Re: Driveway Repaying & Releveling for Fire Station 106 1355 Winding Trail, Mississauga, Ontario L4Y 2V1

Substantial Performance Procurement No.: PRC004168

FIELD REVIEW REPORT #1

Project Name: Driveway Repaving& Releveling

Photo 1: Damaged concrete sidewalk for area#4 has been removed and replaced.

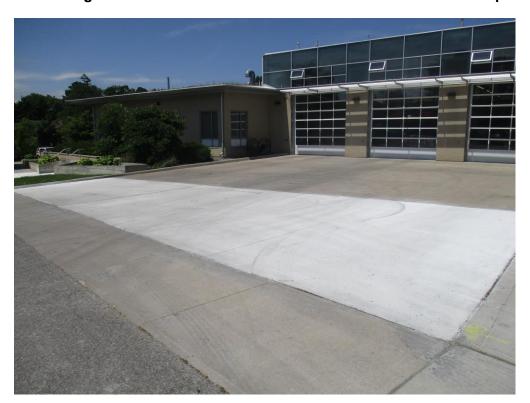
1. Damaged concrete sidewalk for area#4 has been removed and replaced (Refer to photo #1).

Photo 2: Interlock pavers and granular materials for area #3 has been removed and replaced with reinforced concrete slab.

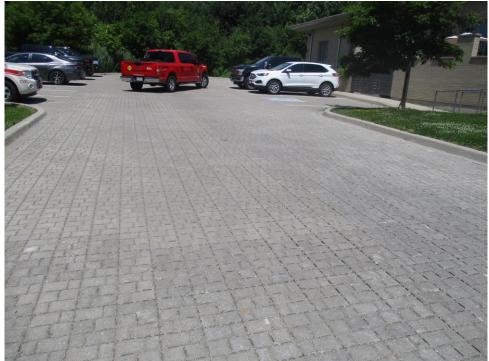
- 2. Interlock pavers and granular materials for area #3 has been removed and replaced with reinforced concrete slab (Refer to photo #2).
- 3. Interlock pavers and granular materials for areas#1 &2 have been removed, granular materials was replaced, compacted and interlock pavers have been reinstated (Refer to photo#3).
- 4. Joint fill material was in place between the interlock gaps at the whole areas not being releveled and reinstated (Refer to photo#4).

Photo 6: All areas disturbed by construction and adjacent concrete sidewalk shall be restored to the original condition by providing local fill, a minimum 100mm topsoil and 50mm sod, the contractor was advised to send photos to our office for review and record after completion of work.

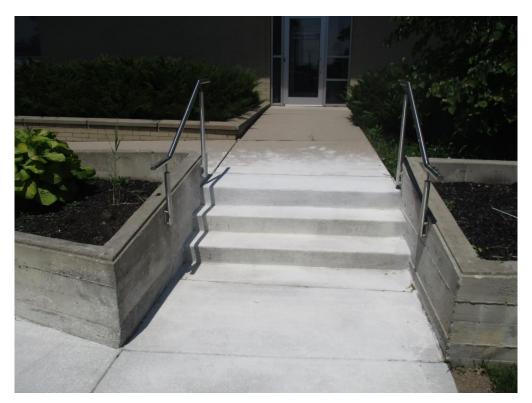
- 2. All areas disturbed by construction and adjacent concrete sidewalk shall be restored to the original condition by providing local fill, a minimum 100mm topsoil and 50mm sod, the contractor was advised to send photos to our office for review and record after completion of work (Refer to photos#6).
